BRAWOOD SUBDIVISION, WALKER ADDITION, **RESUBDIVISION OF LOT 4B**

APPLICATION NUMBER 2 DATE August 6, 2020
 APPLICANT Brawood Subdivision, Walker Addition, Resubdivision of Lot 4B
 REQUEST Subdivision

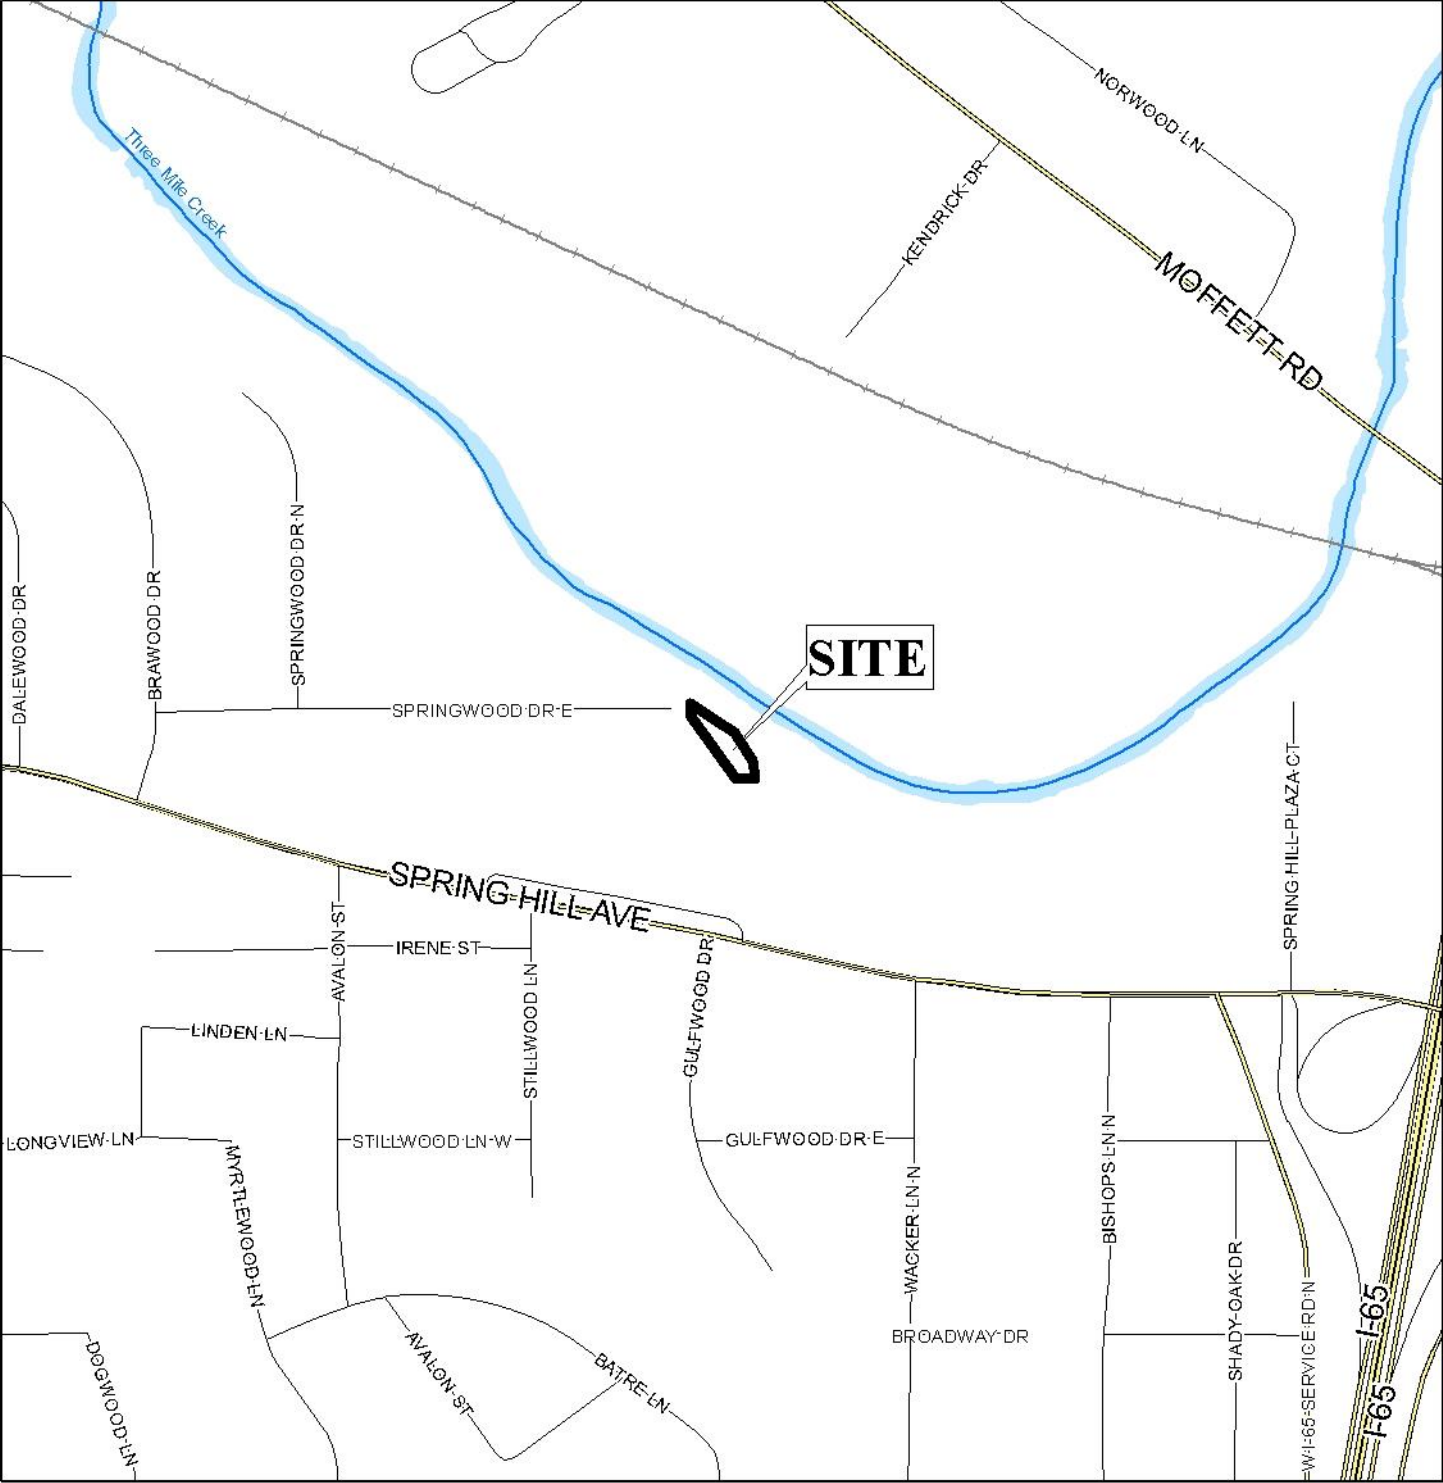
The proposed Lot 4B fronts Springwood Drive East, a minor street with curb and gutter illustrating a compliant 50-foot right-of-way which should be retained on the Final Plat. It is important to note that the proposed subdivision includes a request to include a 5' wide 283'± long strip of land that was previously dedicated to the City for the construction of a Three Mile Creek Parkway. The plat notes that the strip has since been vacated. If approved, the plat should be revised to include reference to the document recorded in Probate Court regarding the vacation.

The preliminary plat illustrates a 77' front minimum building setback, which is what the previously recorded subdivision had. If approved, the front setback should be retained on the Final Plat.

In accordance with the Subdivision Regulations, the proposed Lot exceeds the minimum lot size requirement. If approved, the lot size labels in both square feet and acres should be retained on the Final Plat or a table should be furnished on the Final Plat providing the same information.

As a means of access management, a note containing the Traffic Engineering comments should be placed on the Final Plat. Additionally, as easements are recorded on the subject property they should be indicated and labeled on the Final Plat, and a note should be placed on the Final Plat stating that no structures shall be constructed or placed within any easement without permission of the easement holder.

The vacation request is due to the fact that a portion of the existing house crosses the existing property line, and the granting the request and the completion of the subdivision process will resolve the issue.

Based upon the preceding, the plat meets the minimum requirements of the Subdivision Regulations and is recommended for Tentative Approval, subject to the following conditions:

- 1) revision of the plat to reference the document recorded in Probate Court regarding the vacation of the strip being incorporated;
- 2) retention of the lot size labels in both square feet and acres on the Final Plat or the furnishing of a table on the Final Plat providing the same information;

- 3) placement of a note on the Final Plat stating that no structure may be placed or constructed within any easement without permission of the easement holder;
